CONFORMED SET

LEVEL 01 AREA A FLOOR
PLAN

Project No.: 04561.01

A0104.A

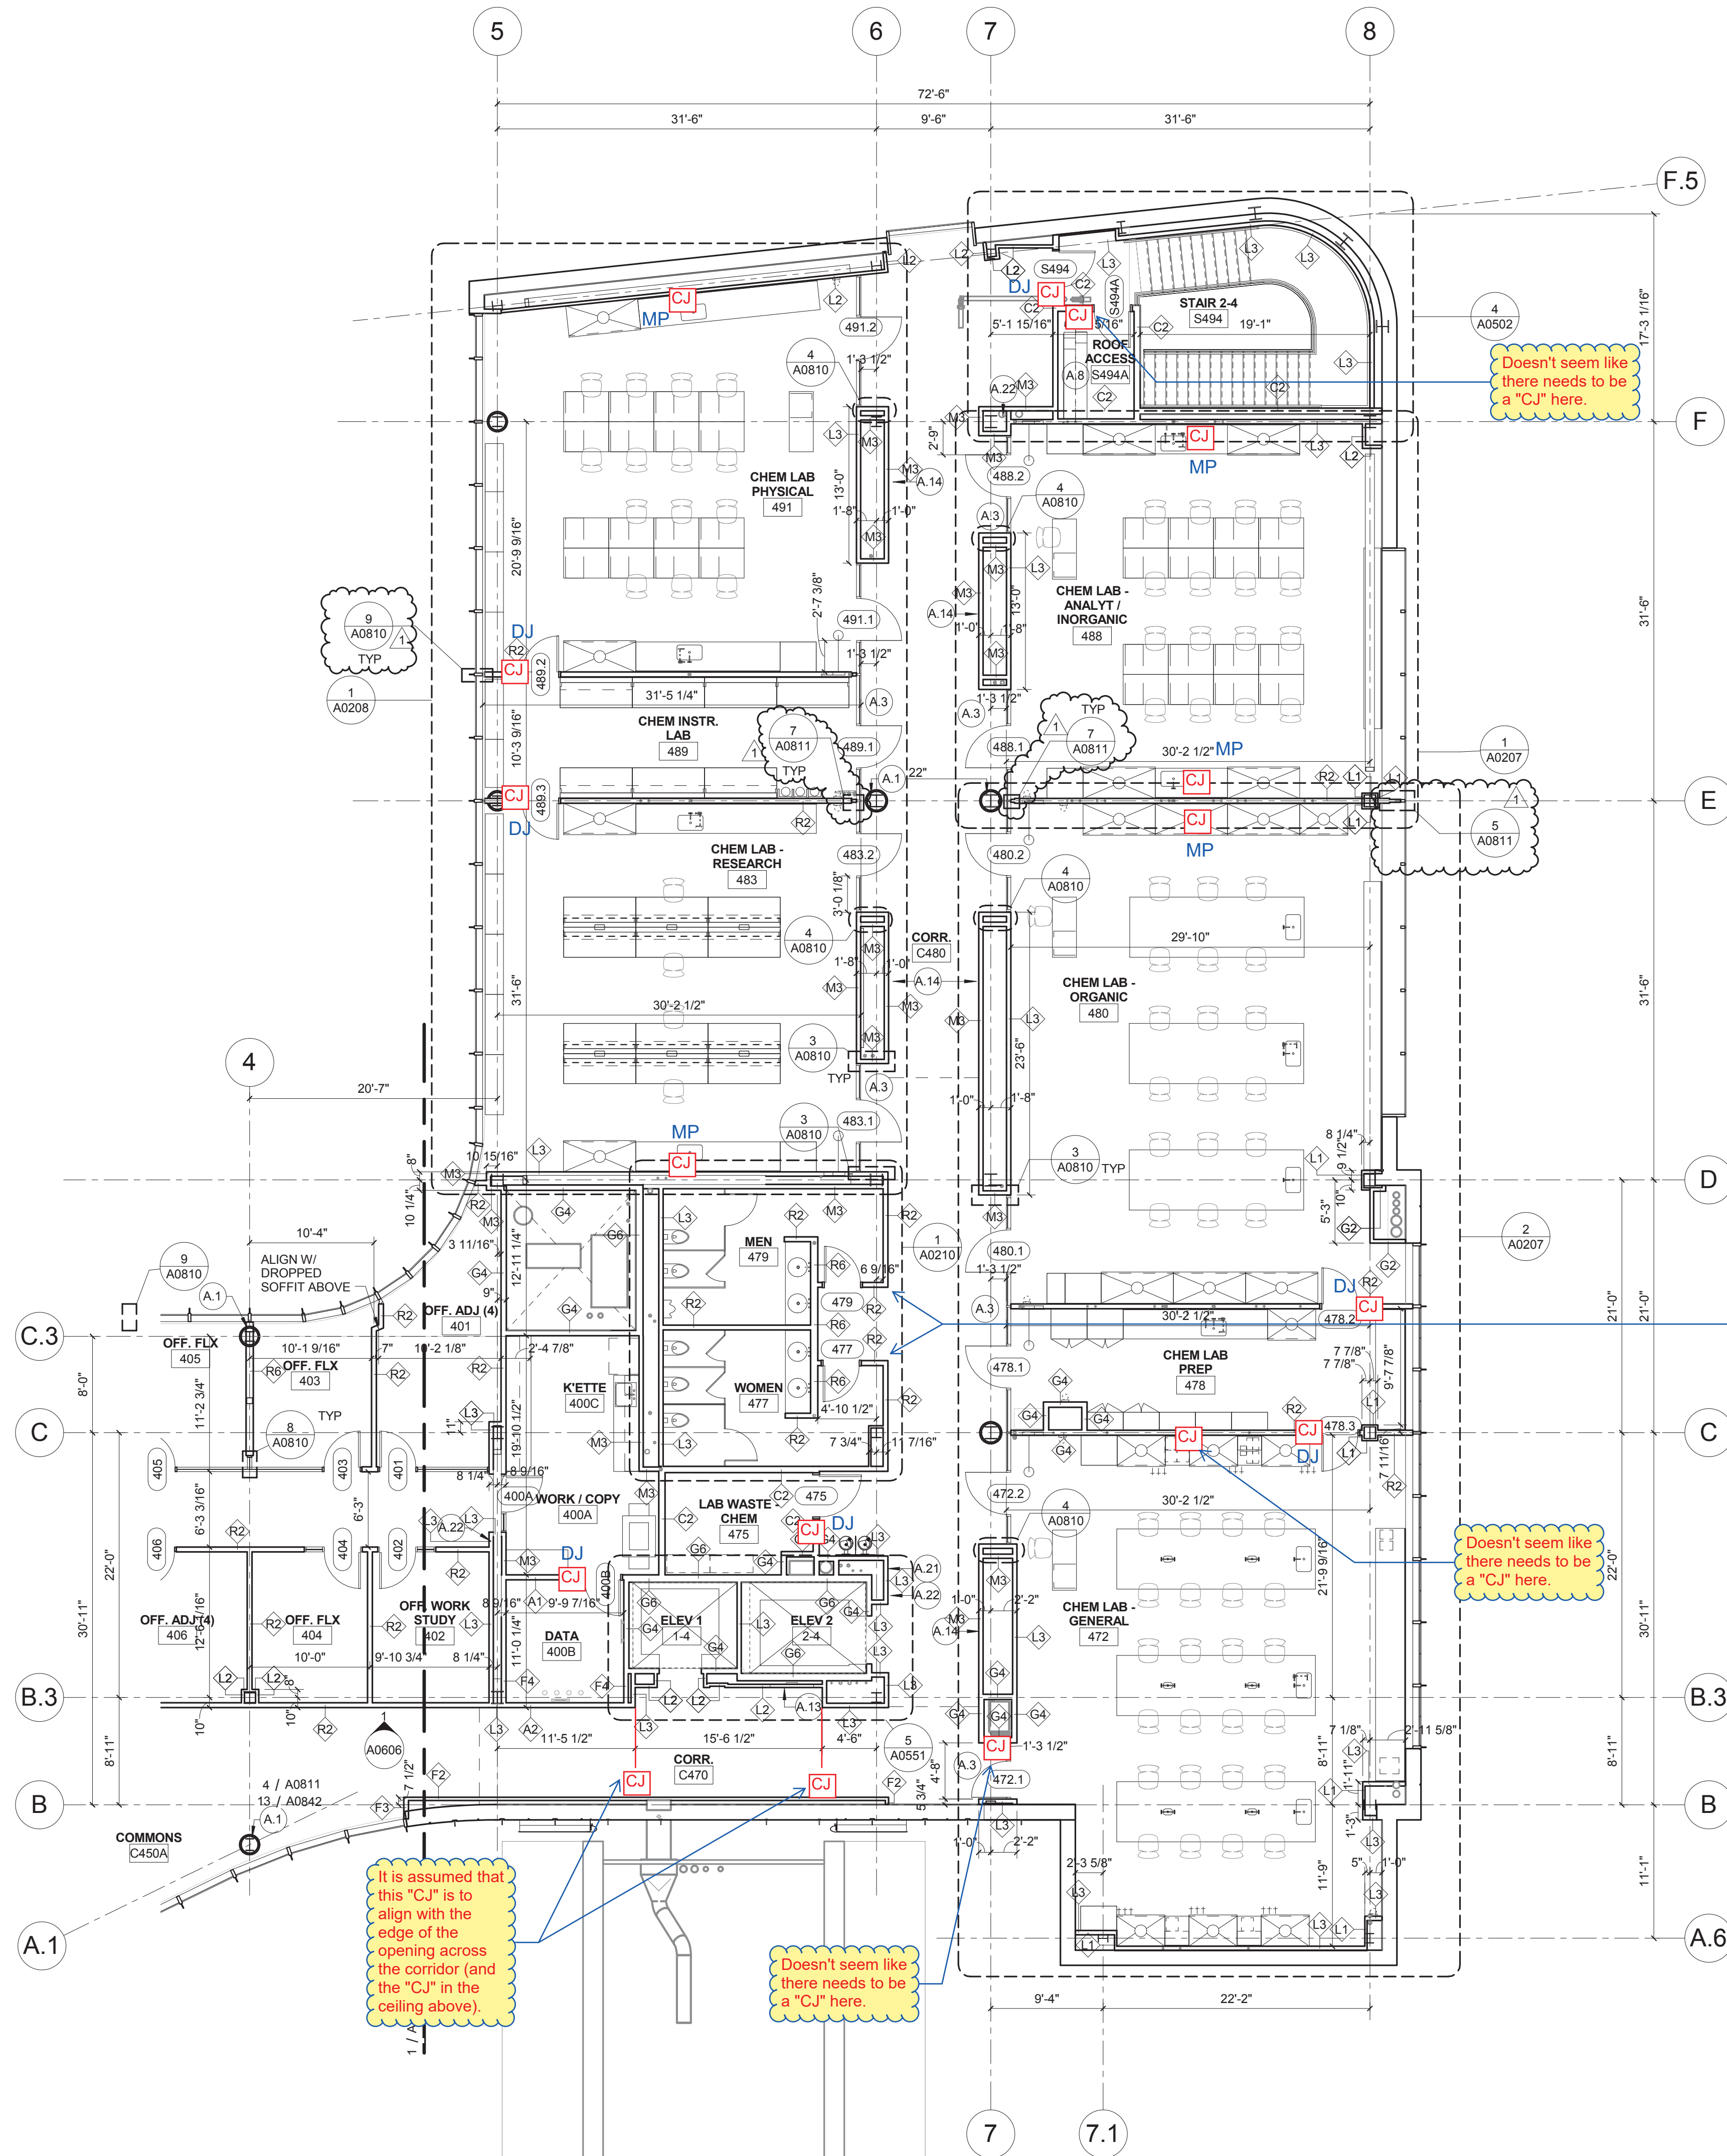
It is assumed that this "CJ" is to align with the edge of the opening across the corridor (and the "CJ" in the ceiling above).

Doesn't seem like there needs to be a "CJ" here.

Doesn't seem like there needs to be a "CJ" here.

Are these "CJ"s supposed to be above the jambs of doors 477 & 479 or are they supposed to be above the corners of this vestibule / alcove? Make sure that whichever location is required, that location is consistent at Levels 2, 3, & 4.

1 LEVEL 02 REFLECTED CEILING PLAN - AREA B

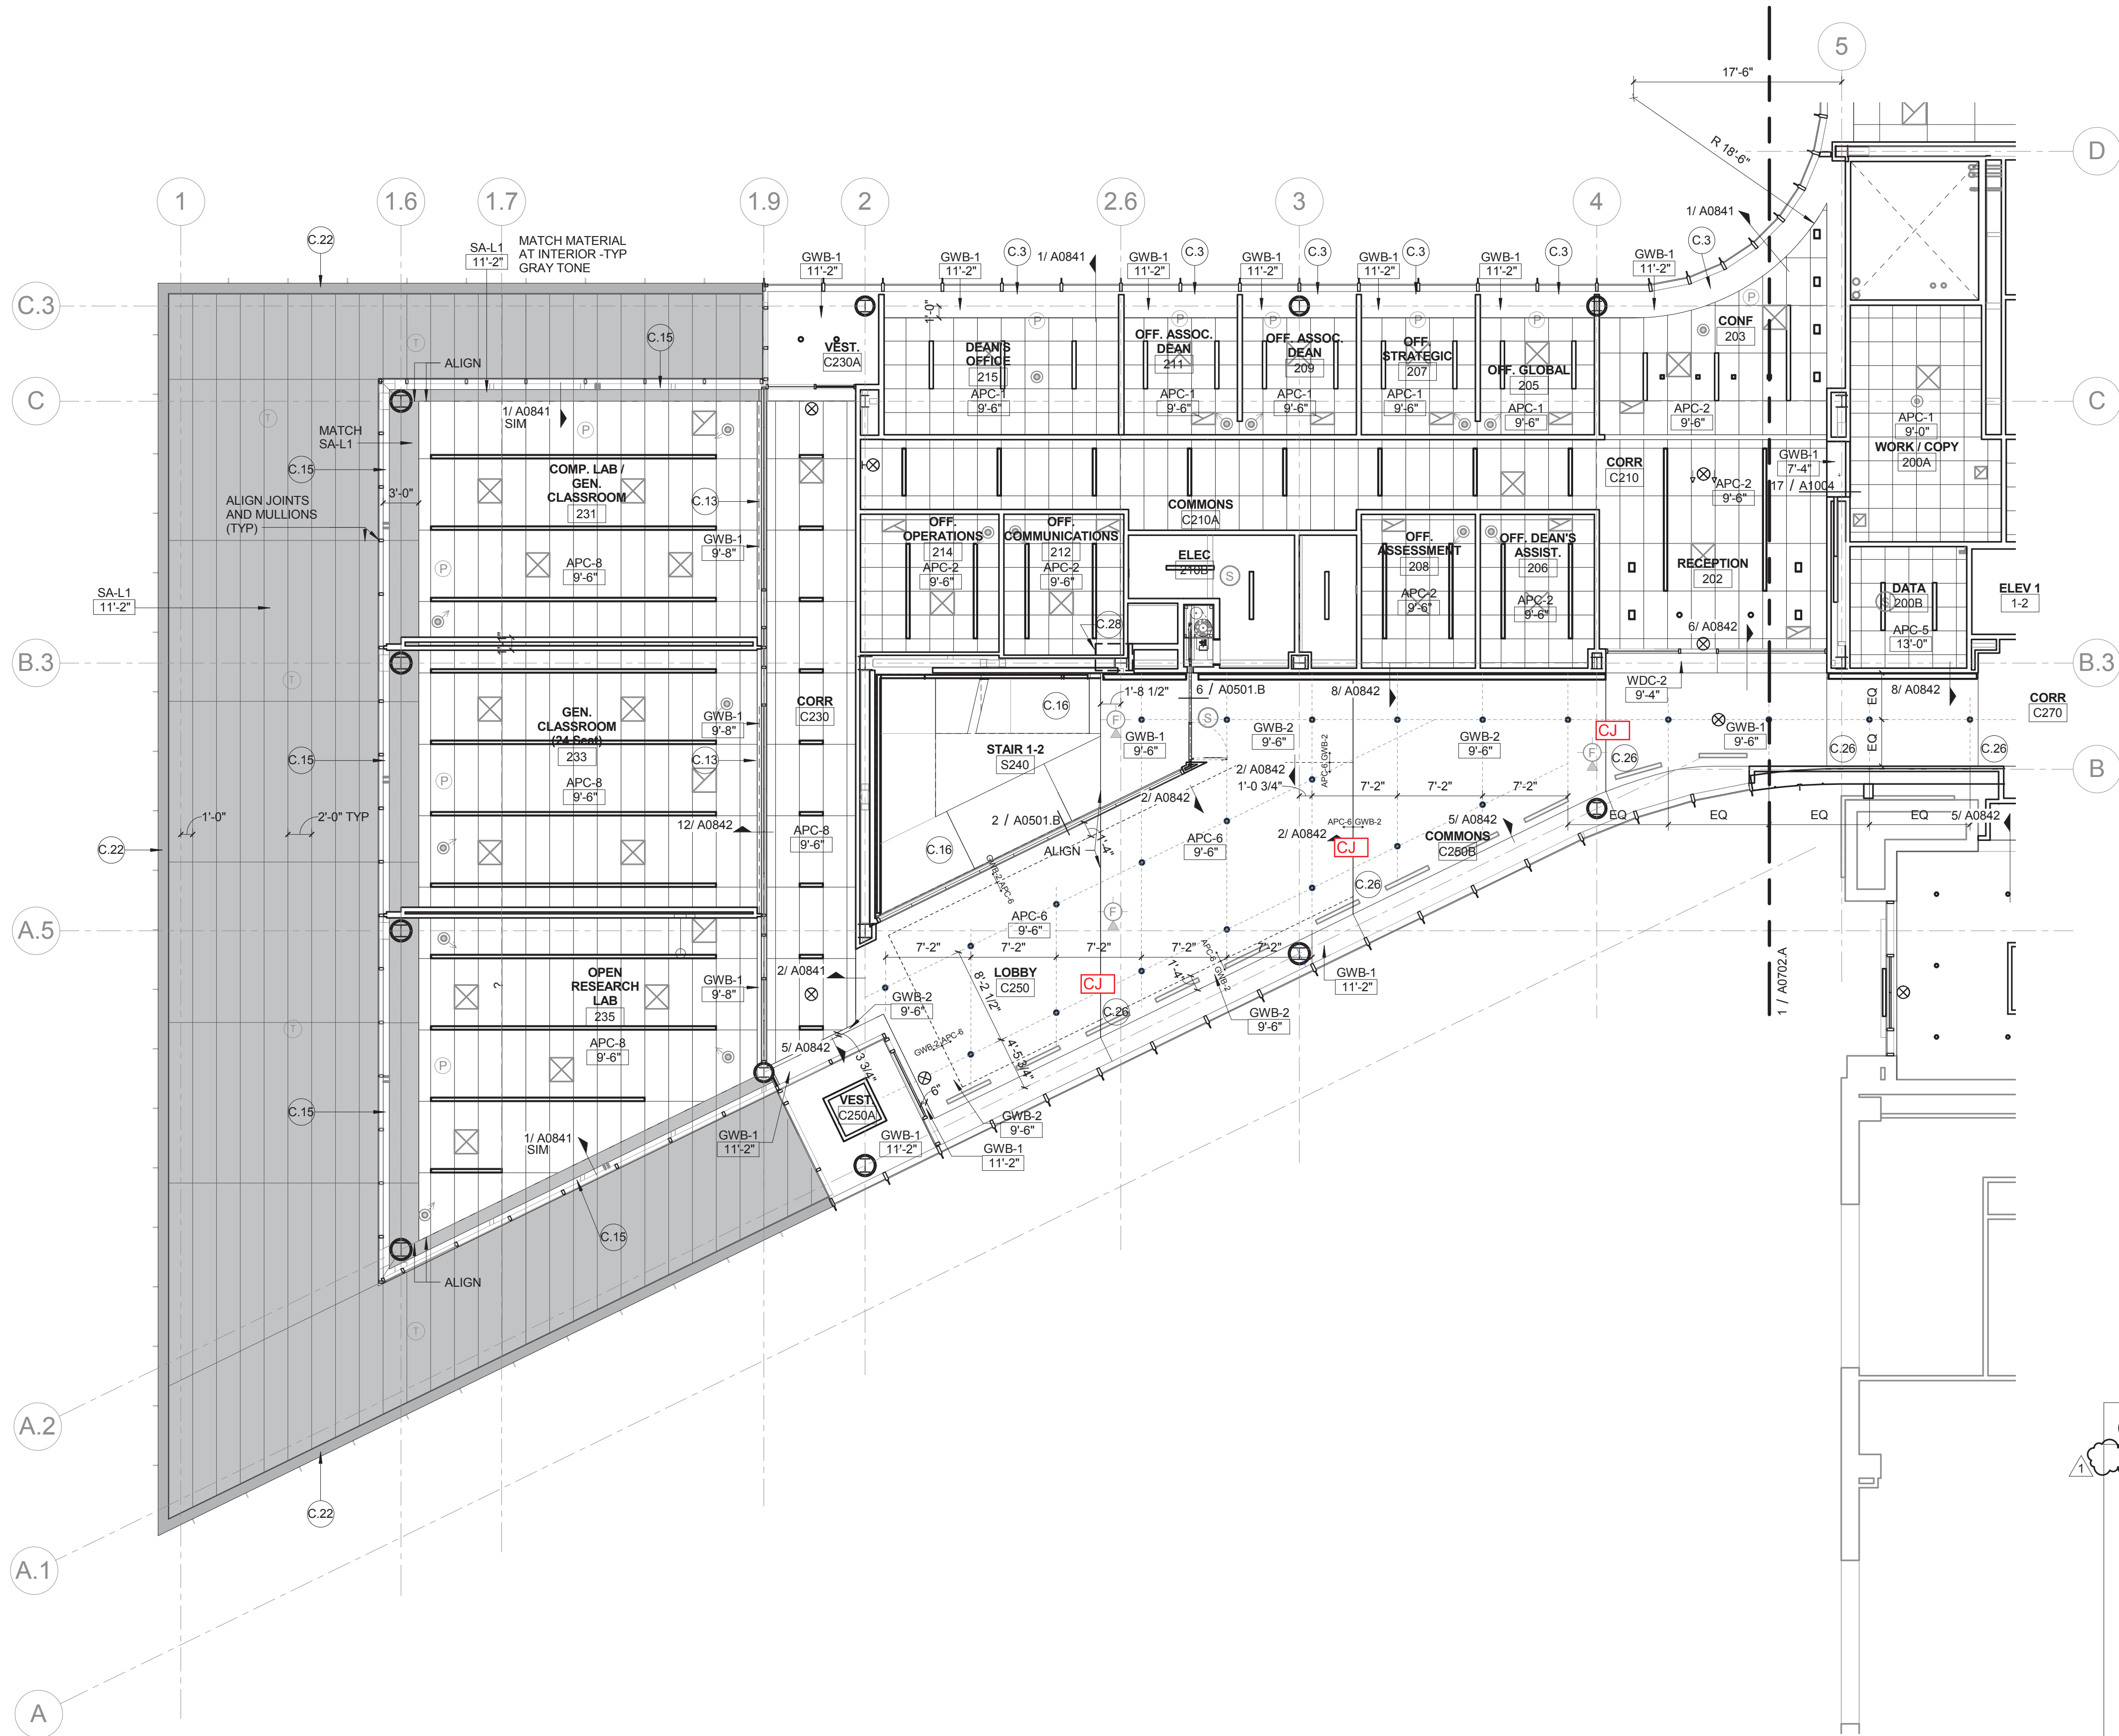
There needs to be a "C.1" here (even though keynote C.26 was not shown here).
